December 5, 2024

BYTEK VW Expansion Project
1325 St. Laurent Blvd.
Ottawa, Ontario
Our Ref: 2301

Addendum N° 5

drawing
PARTIAL BASEMENT PLAN - ELECTRICAL ROOM

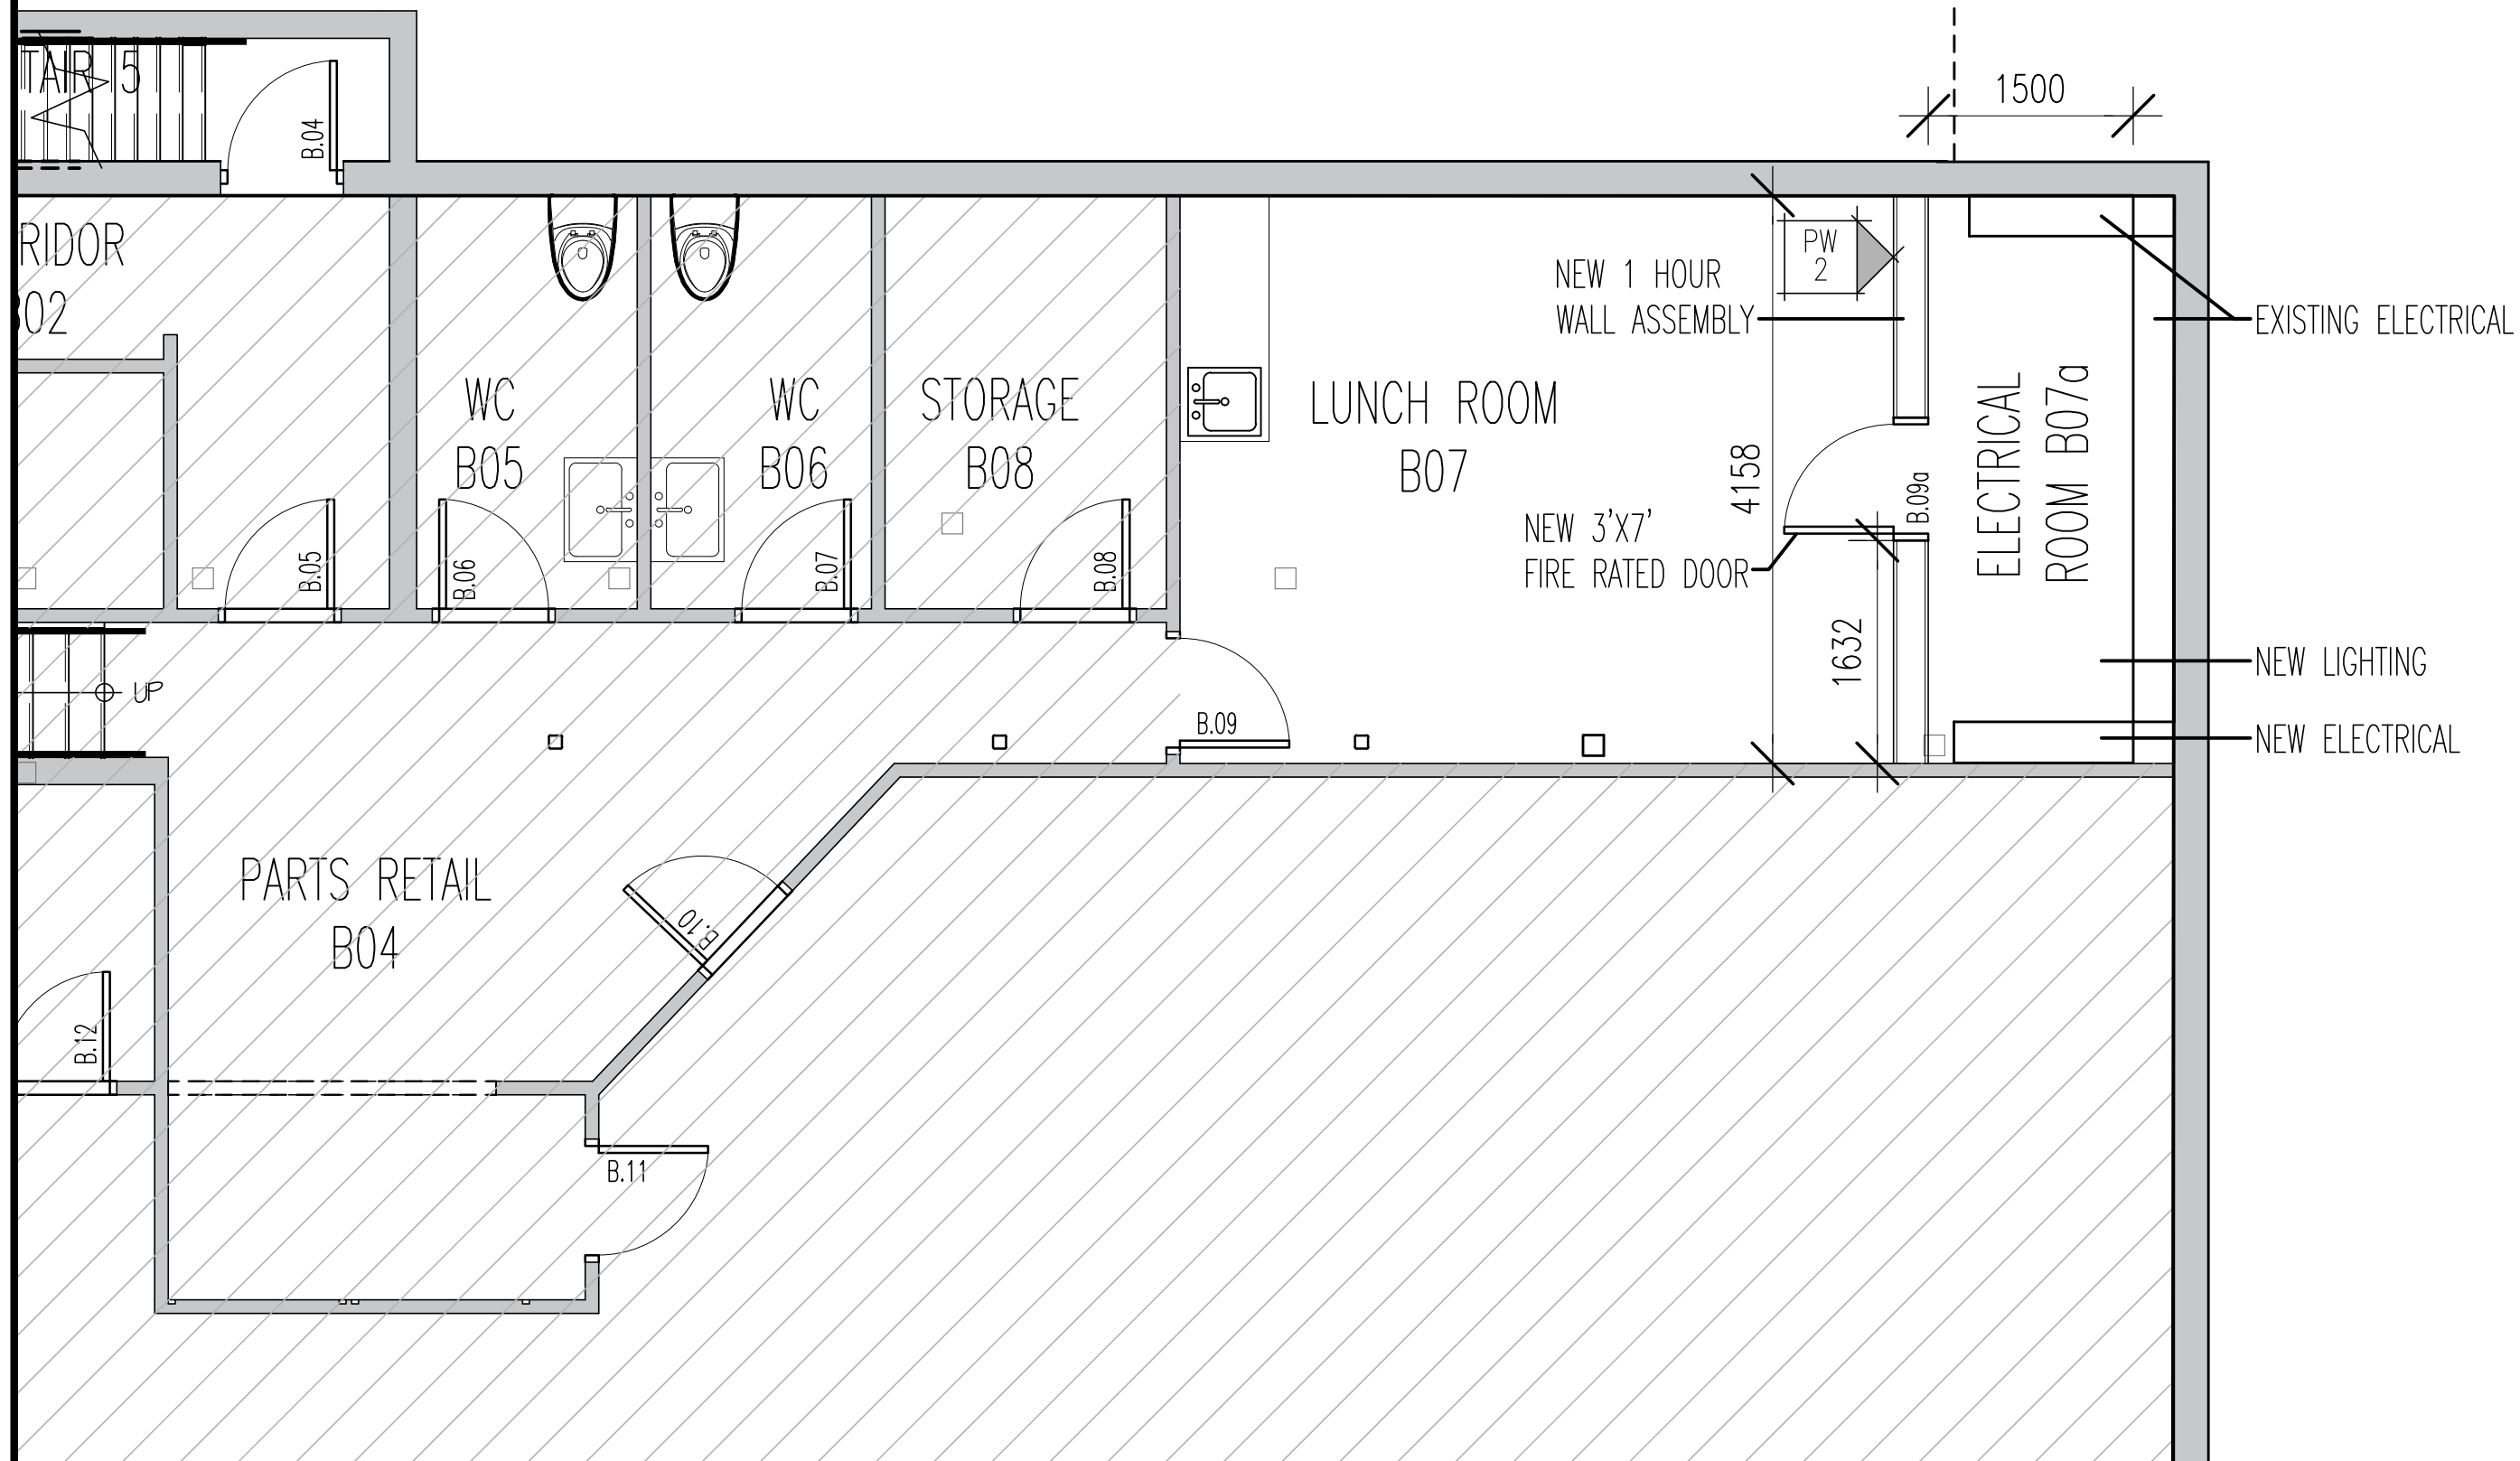
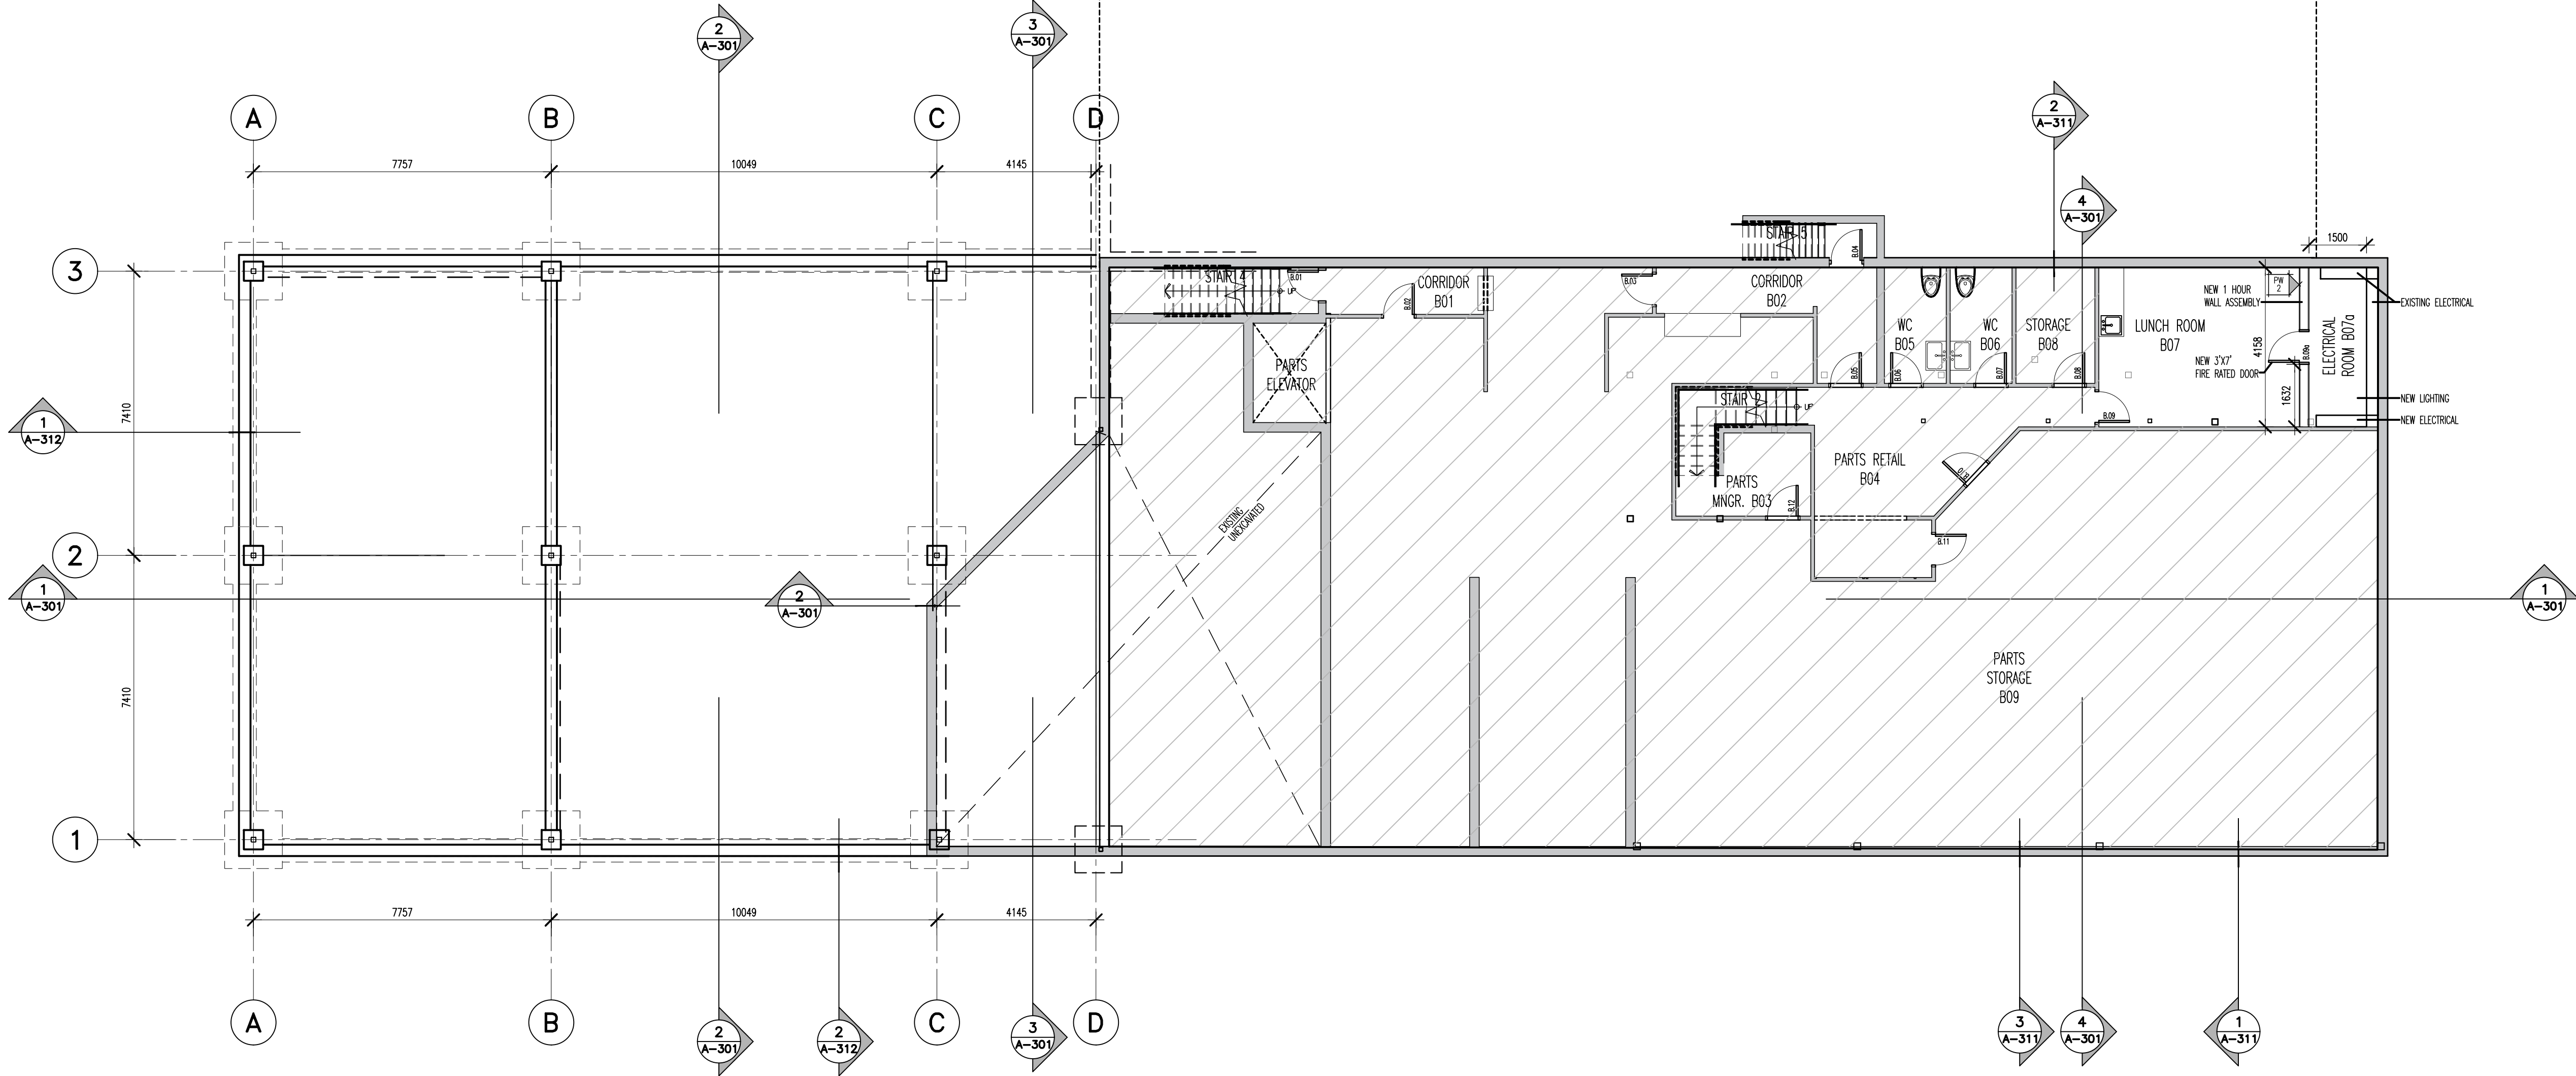
- 1.4 Reference drawings ASK-1, Partial Basement Plan – Electrical Room, Add
 - 1.4.1 Electrical room.
 - 1.4.2 Repair, patch and paint all adjacent surfaces. Maintain all fire separations. Fire caulk around all penetrations in fire rated assemblies.

- 1.4.3 Add plywood backing for all new electrical as required. Refer to electrical.
- 1.5 Reference drawings A-100, Schedule Partitions, Revised
 - 1.5.1 Revise partition assemblies numbering PW-4 to PW-5.

GROUND FLOOR PLAN

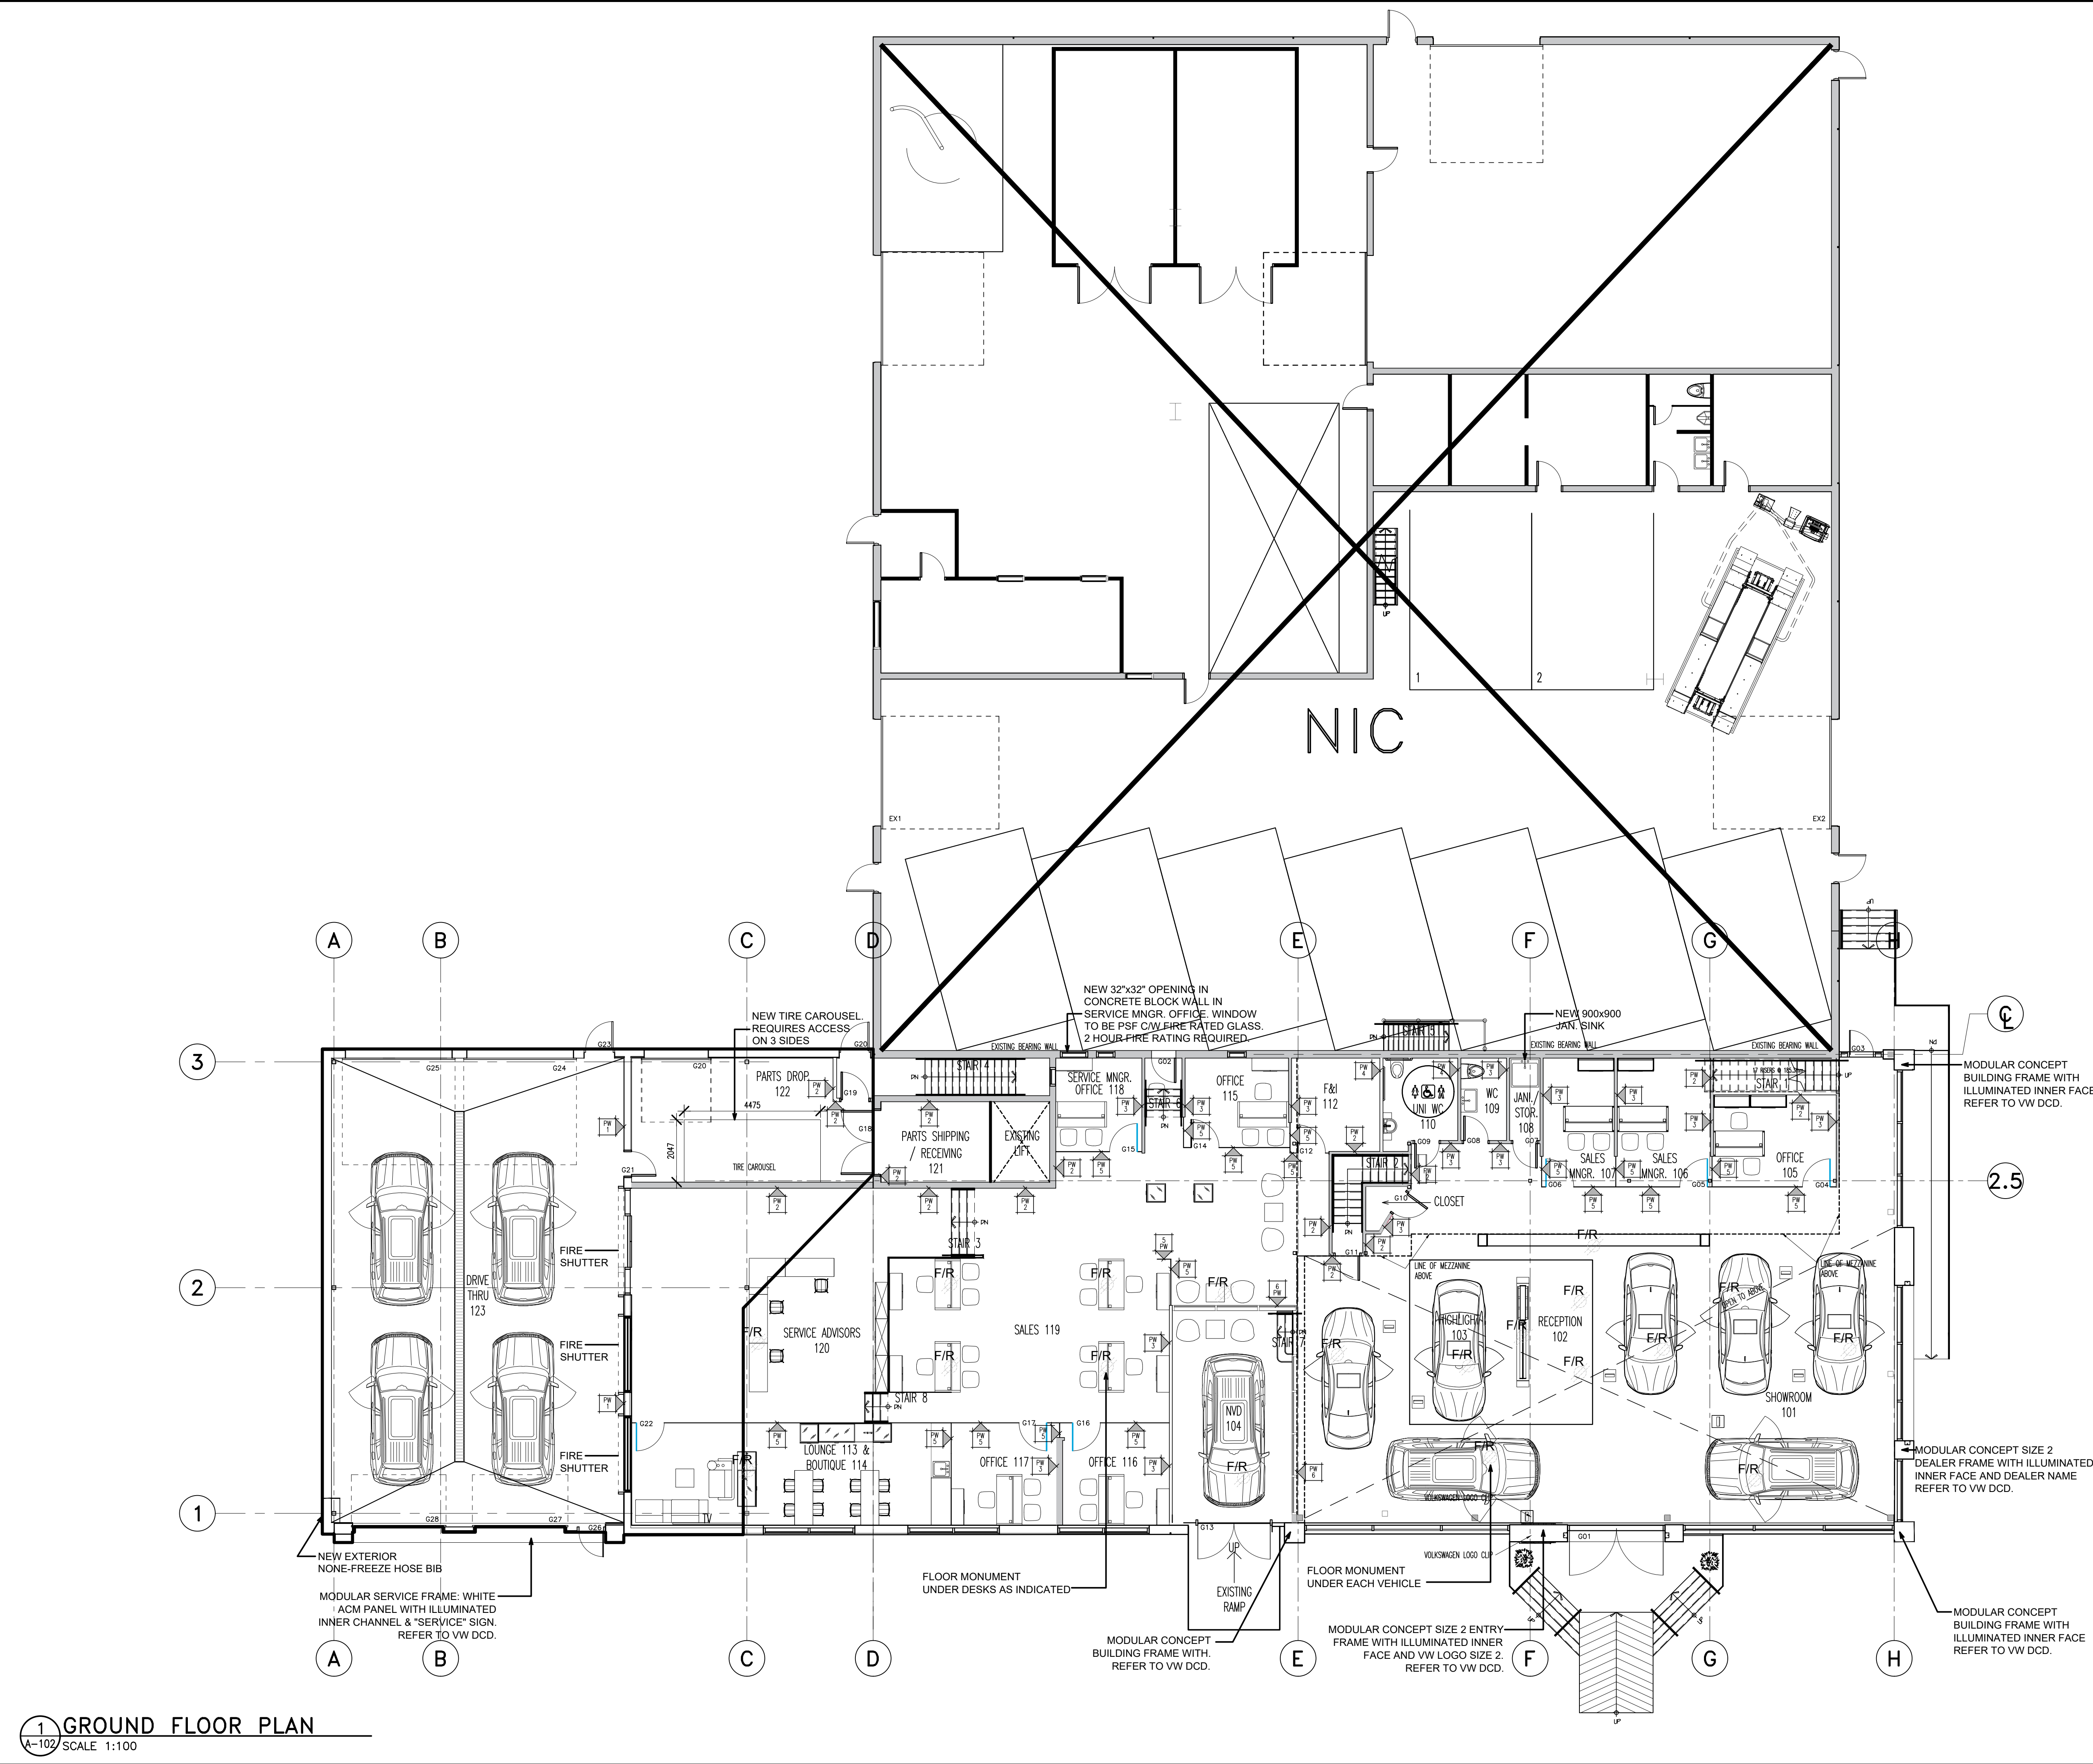
1.7 Reference drawings A-102 Ground Floor Plan, Clarification

1.7.1 No demountable partitions.

1.7.2 Add janitor sink.

1.7.3 Change swing doors in Parts Delivery.

1.7.4 Add tire Carousel in Parts Drop.

1.7.5 Add non-freeze hose bib at exterior.

1.8 Reference drawings A-102 Ground Floor Plan, Add Service Manager Window

1.8.1 Provide 2'-8" x 2' x 8" (810mm x 810mm) opening in existing 2 Hour rated block, opening to be cut within existing block courses. Provide 1-1/2 Hour rated PSF and Fire rated glass. Reinstate wall on both sides for paint finish.

1.9 Reference drawings A-102 Ground Floor Plan. Clarification for overhead doors and fire shutters

1.9.1 2 (two) different types of Overhead Doors.

1.9.1.1 Type 1:

1.9.1.1.1 Replace 2 (two) existing overhead doors and operators. Doors to be replaced are EX1 and EX2.

1.9.1.1.2 Overhead Doors located in Drive Thru 123 and EX1 and EX2 to be 12'x12' Richard Willcox model P175, clear anodized rails with clear polycarbonate, 3" hardware, std lift, steel jamb, 1"dia solid shaft c/w coupling, 100,000 cycle springs, perimeter weatherstrip, Electric motor, heavy duty, c/w spreader bar, 3 button push station, photocell safety.

1.9.1.2 Type 2:

1.9.1.2.1 Overhead Door located in Parts Drop 122 to be insulated steel overhead door c/w 3 vision panels.

1.9.1.3 Install bent steel plate jambs for G20, G24, G25, G27, G28 overhead doors.
